ADDENDUM No. 1

April 12, 2024

**Southfield Fire Stations #4 & #5
PAVING IMPROVEMENTS
0153-23-0180**

This Addendum contains 41 pages.

WALL CROSS-SECTION

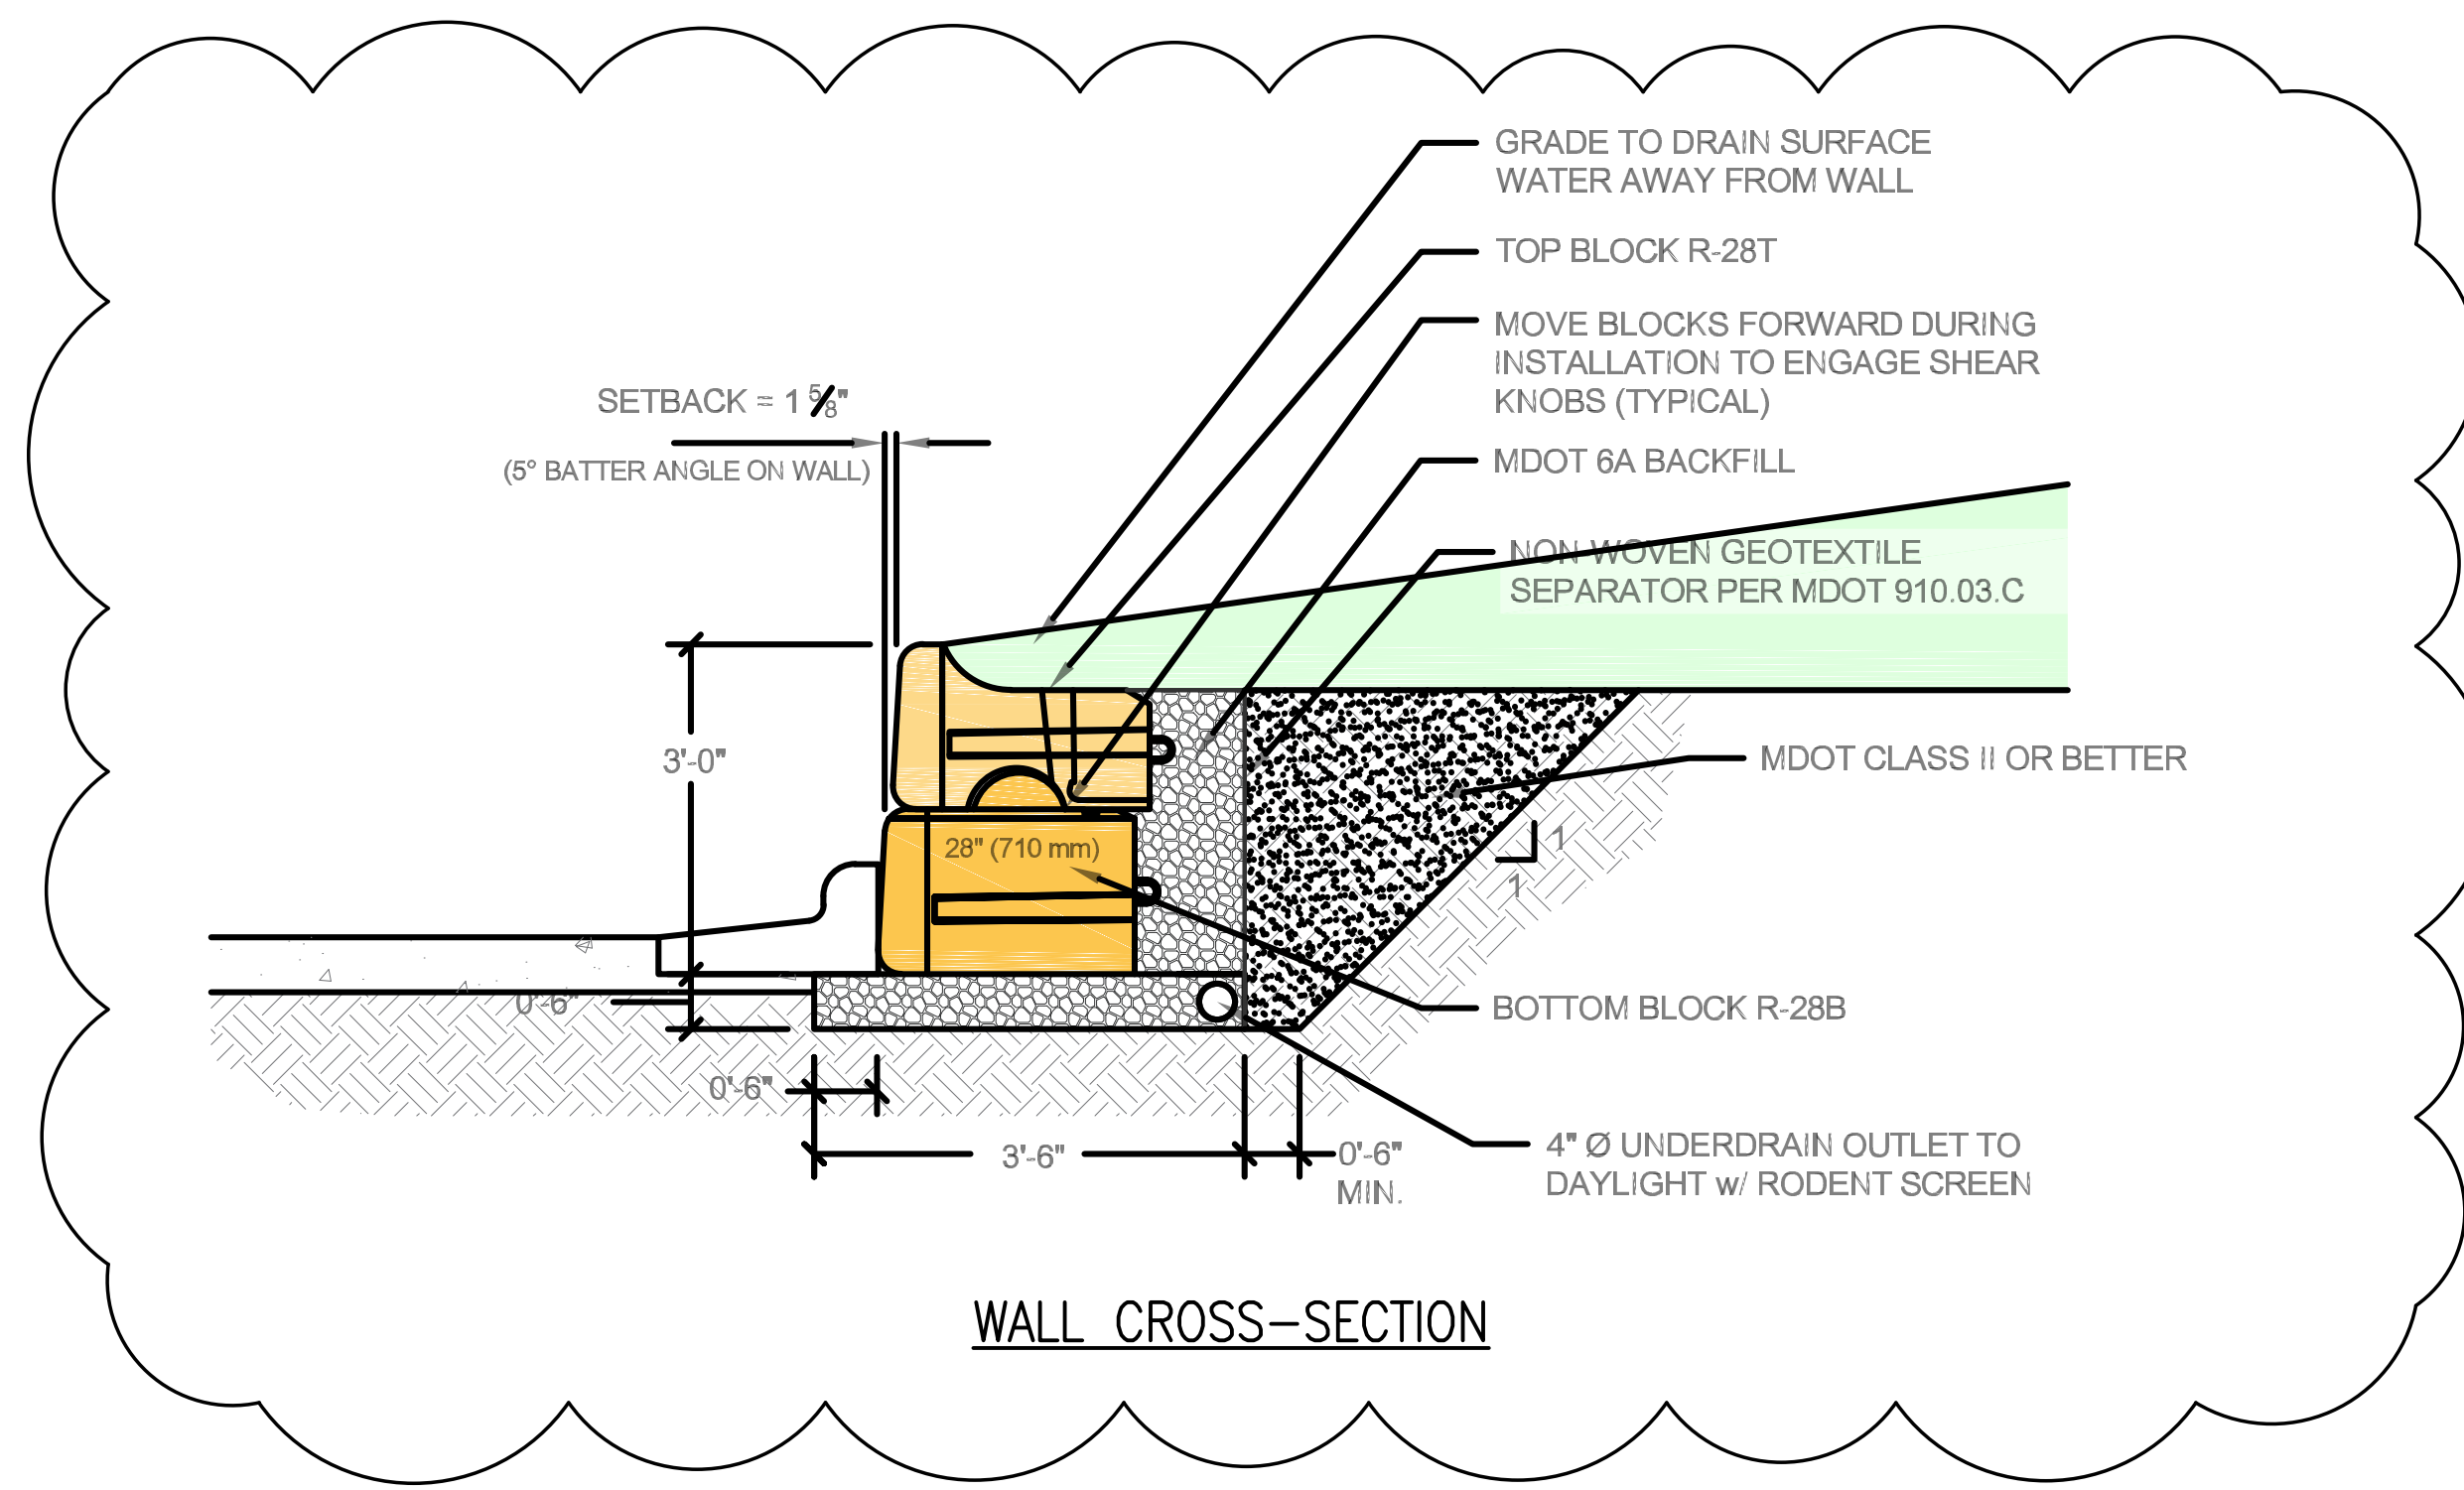
10. Replace plan sheet C-502 with revised plan sheet attached to this addendum.
 - a. Revised retaining wall cross-section detail.
11. Replace plan sheet C-503 with revised plan sheet attached to this addendum.

1. I have a question about a detail on page C-502, the wall cross section detail. It shows a stone retaining wall, but I don't see a line item on the bid form for a stone retaining wall. Is that being corrected or should I include that pricing in another line item?
 - a. The detail on sheet C-502 corresponds to the new bid item #51, Redi Rock Retaining Wall.
2. I was going through the drawings and looking for more detail on the bike hoop. I can't find a specific manufacturer, has one been spec'd yet?
 - a. Any manufacturer can be used, provided it meets the specifications noted on the details.

TYPICAL TRASH SCREEN DETAIL
SCALE 1:5

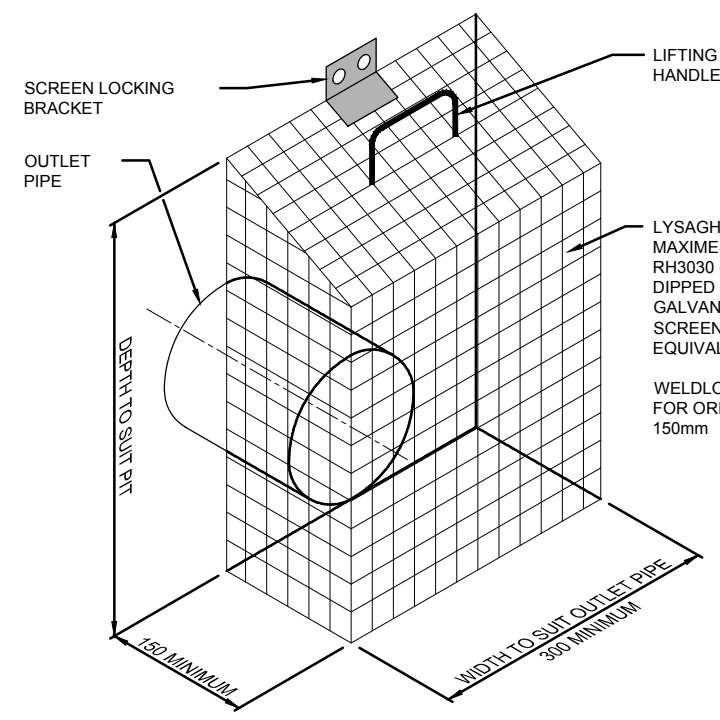
- a. Updated the outlet control structure detail per revised stormwater and added a trash screen to the proposed 1" orifice.
 - b. Added a trash screening detail.
